**MONTGOMERY COUNTY HISTORIC PRESERVATION COMMISSION**  
**STAFF REPORT**

<b>Address:</b>	4811 Cumberland Ave., Chevy Chase	<b>Meeting Date:</b>	8/12/2020
<b>Resource:</b>	Primary (Pre-1915) Resource (Somerset Historic District)	<b>Report Date:</b>	8/5/2020
<b>Applicant:</b>	James Belikove & Vanessa Piala (Jason Arce, Agent)	<b>Public Notice:</b>	7/29/2020
<b>Review:</b>	HAWP	<b>Tax Credit:</b>	N/A
<b>Case Number:</b>	35/36-20B	<b>Staff:</b>	Michael Kyne
<b>PROPOSAL:</b>	Construction of new rear addition, hardscape alteration

# Belikove-Piala Residence

**Fig. 5: Historic house core in red.**

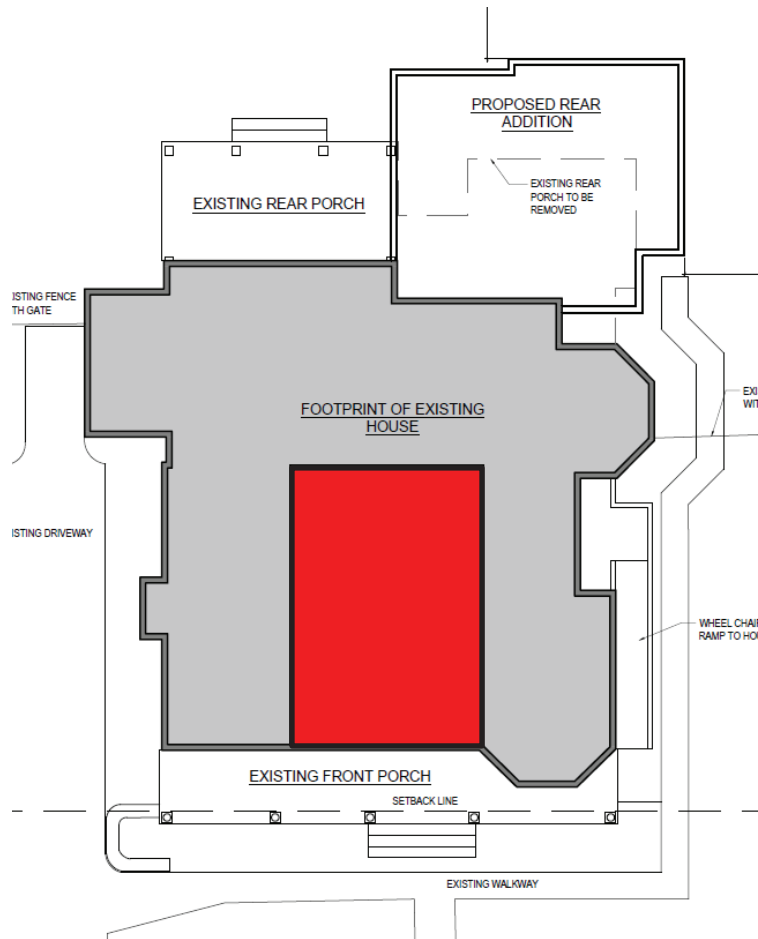
- The Commission recommended that the outline of the historic core be depicted in the floorplans, when submitting a formal HAWP application.

- Existing photographs of the front of the house have been provided.
- The historic house core has been depicted on the proposed site plan (see Fig. 5 below).
